STATE OF WASHINGTON
DEPARTMENT OF ECOLOGY

Re: Opinion pursuant to WAC 173-340-515(5) on Proposed Remedial Action for the following Hazardous Waste Site:

- **Site Name:** GSA Federal Center S. Bldg 1206
- **Site Address:** 4735 E. Marginal Way S., Bldg 1206, Seattle, Washington
- **Facility/Site ID No.:** 18866
- **VCP Project No.:** NW2930
- **Cleanup Site ID No.:** 12493

Corporate Office 17522 Bothell Way Northeast Bothell, Washington 98011 Phone: 425.415.0551 Fax: 425.415.0311	GSA Federal Center South Building		Figure 2
	RGI Project Number 2013-364	Site Representation Map	Date Drawn: 07/2014
	Address: 4735 East Marginal Way South, Seattle, Washington 98134

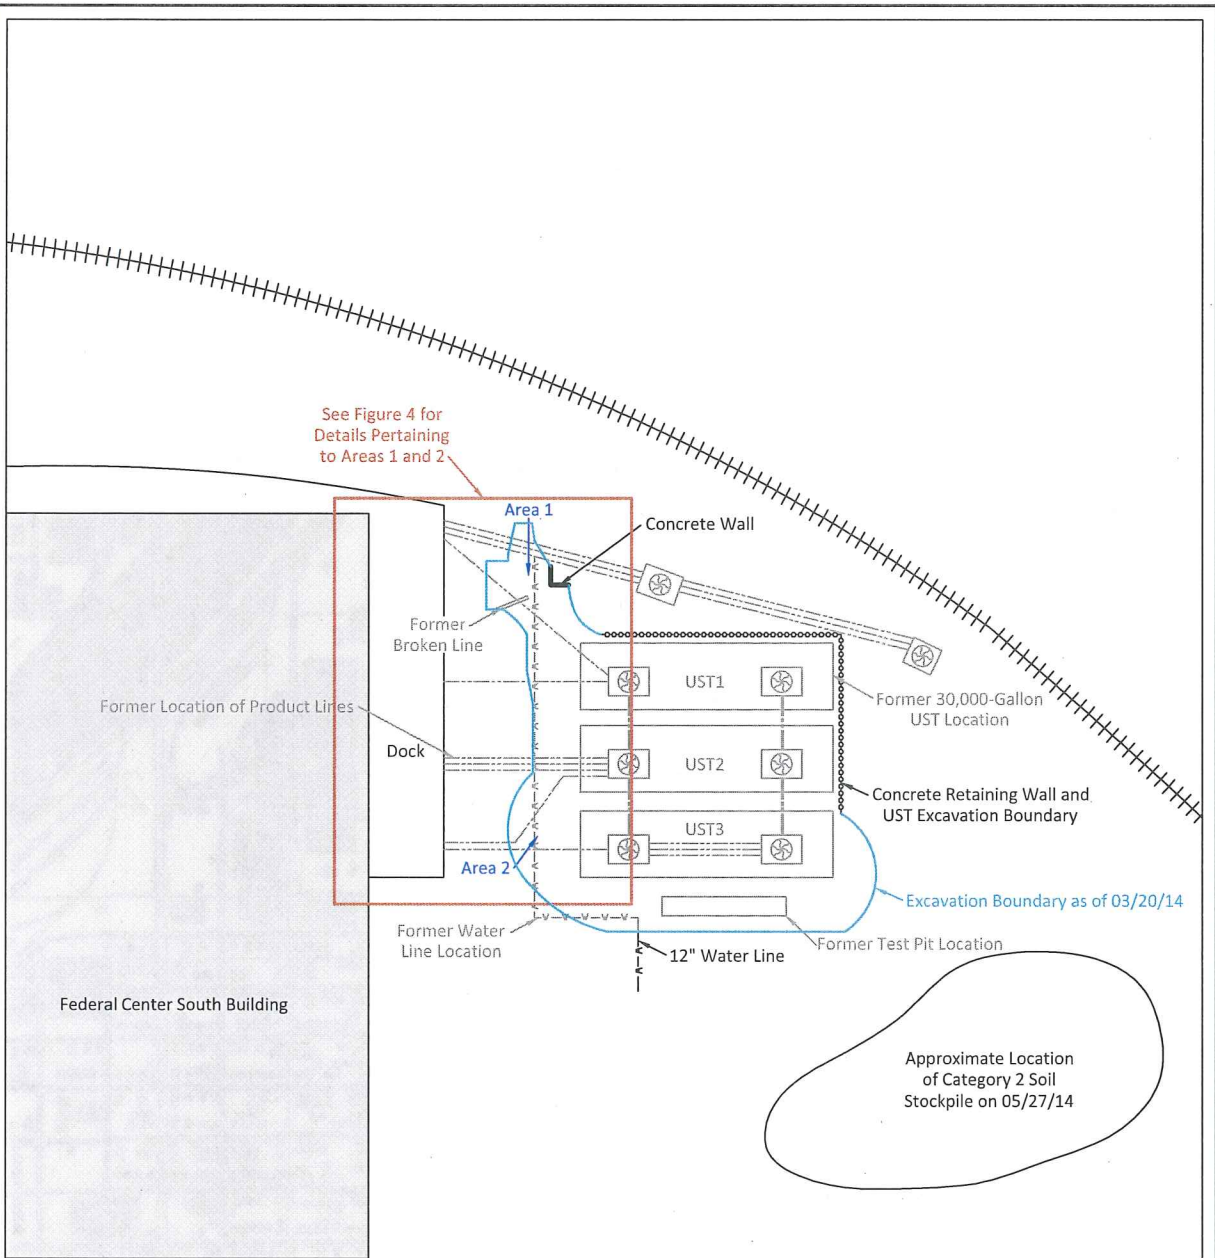
- Figure 2 of the 2014 UST Closure report shows the excavation boundary as of 03/20/14 while Figure 3 shows the excavation boundary as of 05/27/14 but both figures show the same boundary. If it is the same boundary on both dates, the label should be shortened to “Area 2 Excavation Boundary” on both figures.

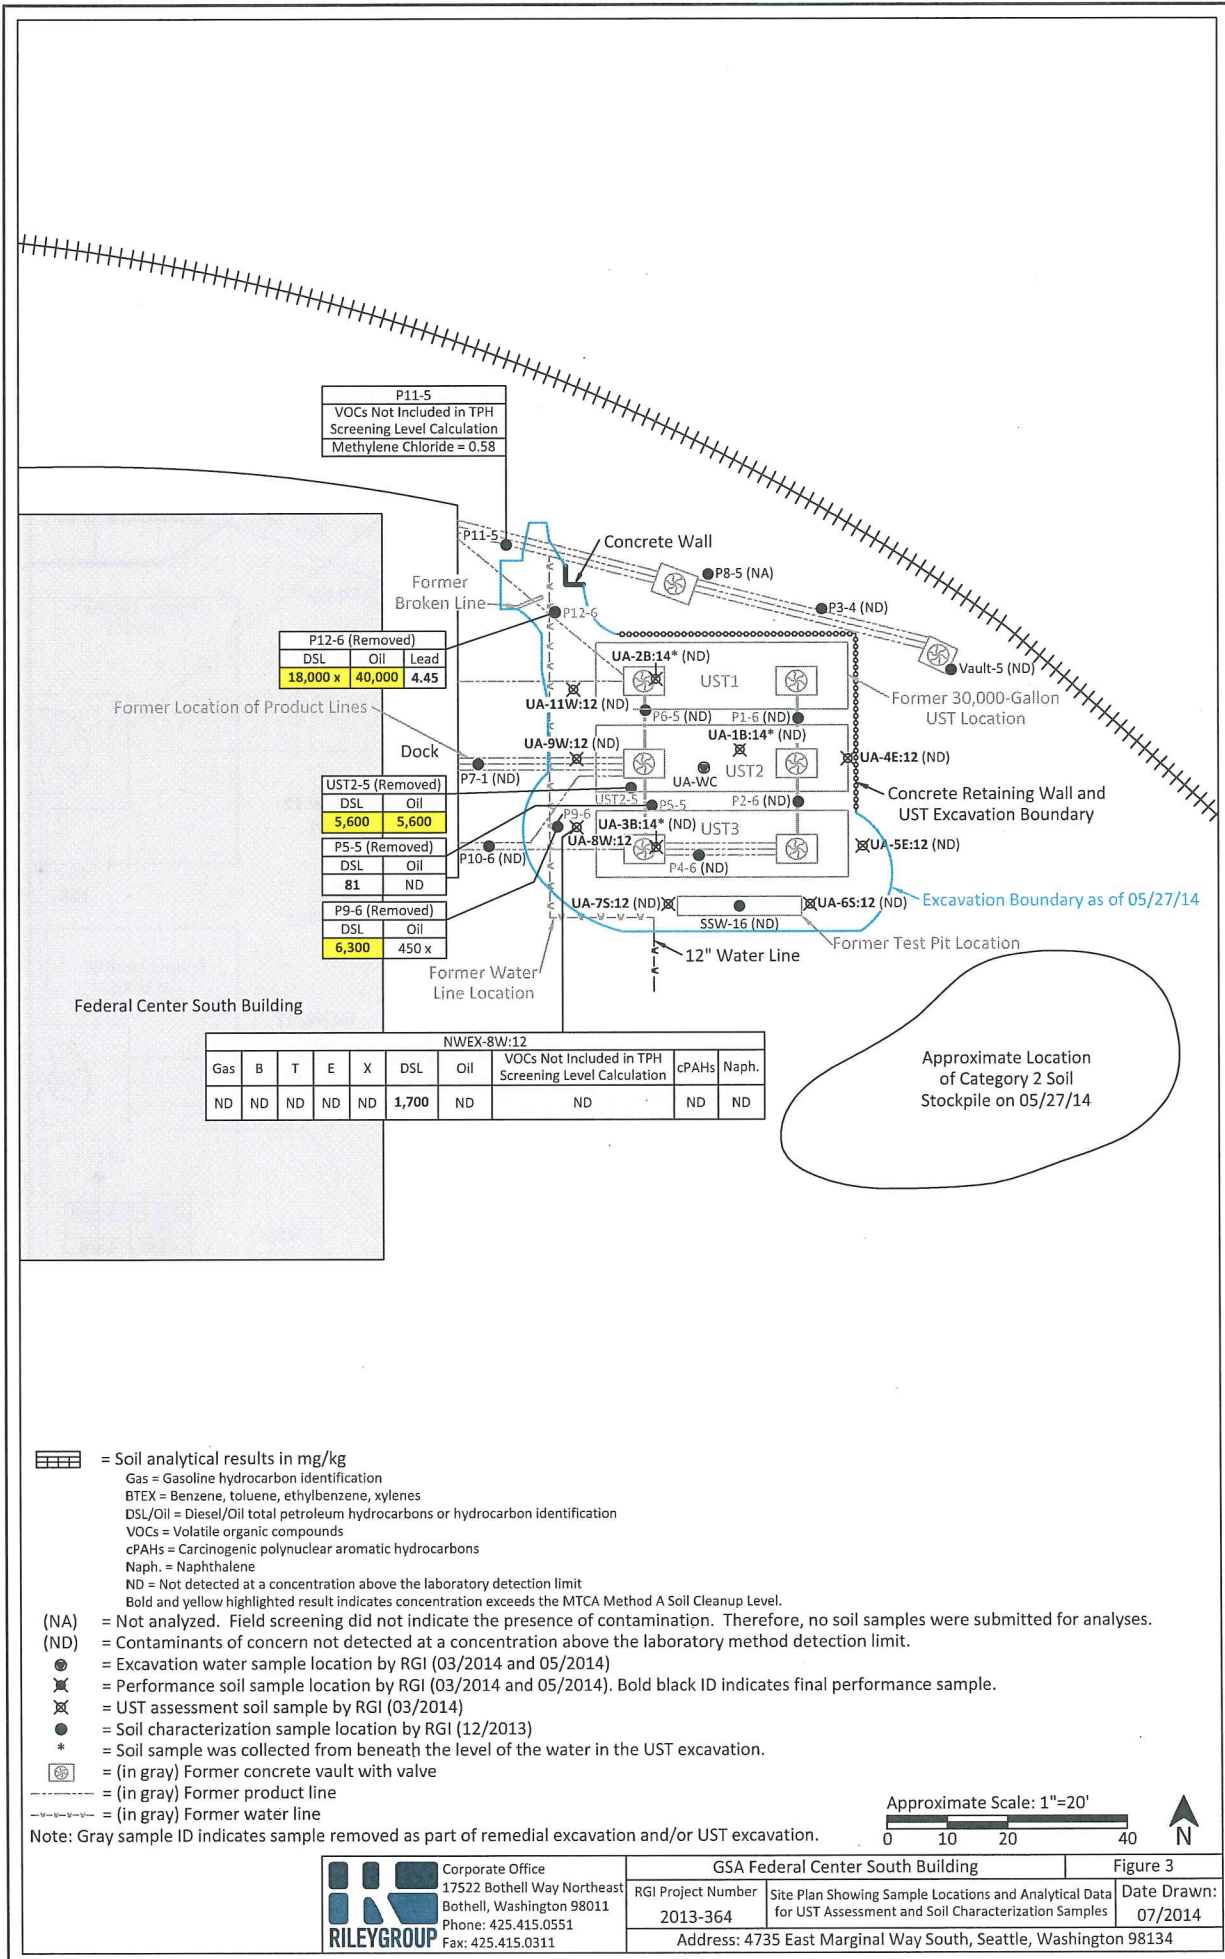
- The report (page 5) states that 23 soil characterization samples were collected from soil overlying the USTs and along some piping runs, and references Figure 3. Figure 3 shows 25 soil sample locations. The figure legend contains symbols for soil characterization samples, UST assessment soil samples and performance soil sample locations. The figure needs to indicate which samples were collected above the USTs.

- Figure 3 of the report shows a former test pit location south of the USTs. The test pit is not described in the text and no text pit log is included in the report appendices. The rationale for both the test pit excavation and soil sample collection as well as the results, need to be discussed in the text.

- Figure 3 shows the results of soil sampling. On all figures, Please include the concentration of the laboratory reporting limit with a ‘<’ symbol rather than using ‘ND’. Also, if displaying data, include the analyses that were conducted. For example, the samples P11-5 and Vault-5 are shown as ‘ND’ but neither was analyzed for TPH-D and TPH-O.

- Figures 3 and 4 of the report include notes for samples stating ‘VOCs Not Included in TPH Screening Level Calculation’. No screening level calculations are discussed in the text or presented in Table 1 so this notation should be eliminated.

- One soil sample, P7-1, is shown in Figures 3 and 4 to represent soil at the three former product lines leading into Building 1206. The sample was collected at a depth of 1 foot bgs. Other product line samples were collected at depths of 4 to 6 feet bgs. The report text needs to include information on the actual depths of the product lines as well as a description of the removal of the product lines.

- Figures 3 and 4 of the report show two former product lines extending from UST1 to Building 1206 that were not sampled. The two figures also show a set of what appear to be product lines and vaults north of excavation A1 but this feature is not discussed in text although several soil samples were collected. One sample, P8-5, was collected but not analyzed, this is also not discussed in the report.

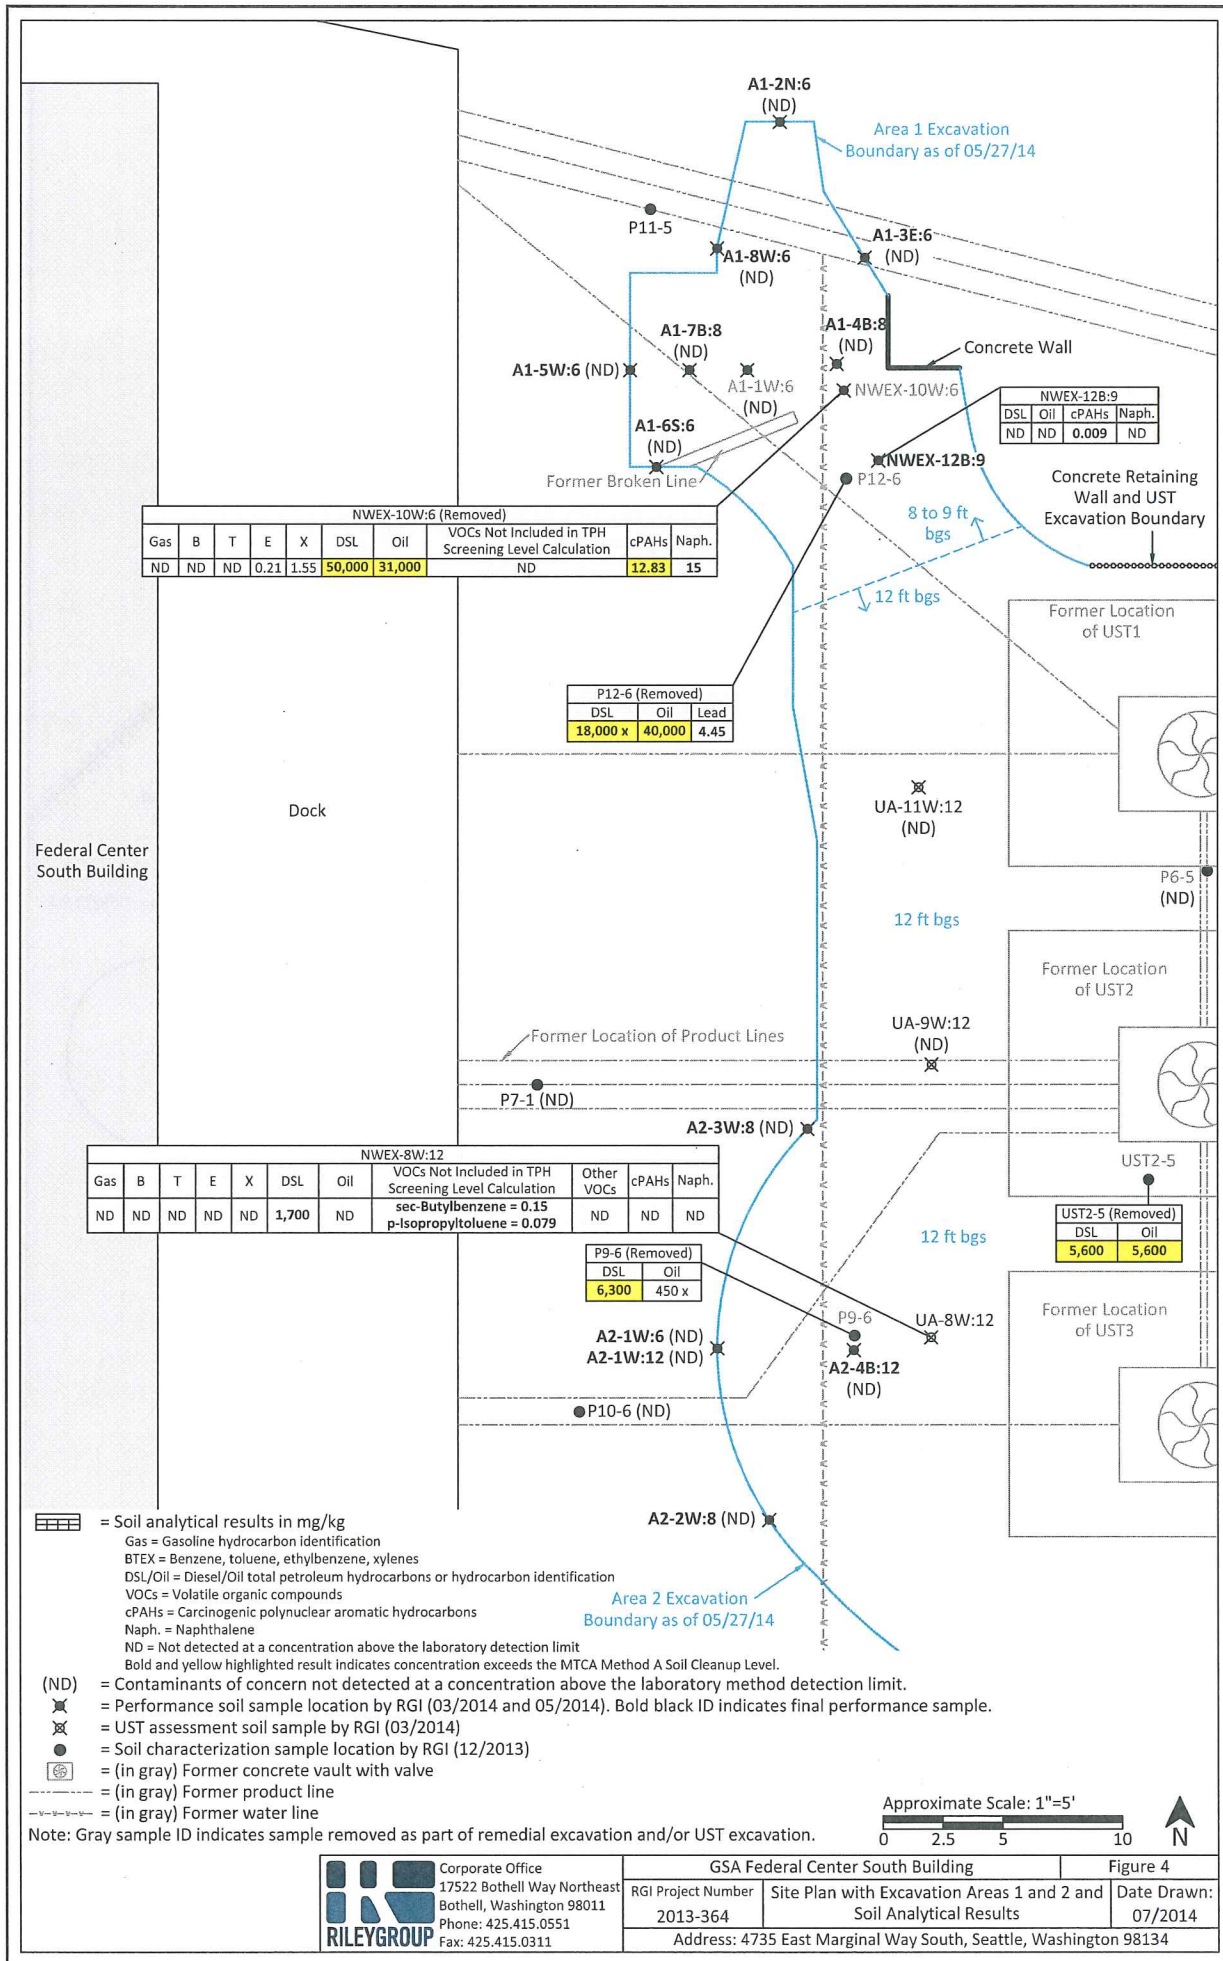
- The report text (Section 9.1; page 8) states that the final limits of each excavation area along with locations of performance and characterization samples are depicted on Figure 4. Figure 4 shows about half of Areas 1 and 2. Is the text referring to Figure 3?

- According to Figure 4, there were no excavation sidewall samples collected along the Area 2 excavation boundary between A1-6S:6 and A2-3W:8. This linear distance, approximately 30 feet, is twice what is stated in the report text as being the general distance between sidewall samples (15 feet).

- Table 1 of the report should differentiate which characterization soil samples were collected from soil overlying the USTs. Table 1 should also indicate which soil samples are sidewall and bottom samples. A soil sample in Area 1 is called “A2-3E:6” but appears to be actually named “A1-3E:6” in Figure 4. The table should be corrected with the correct sample name.
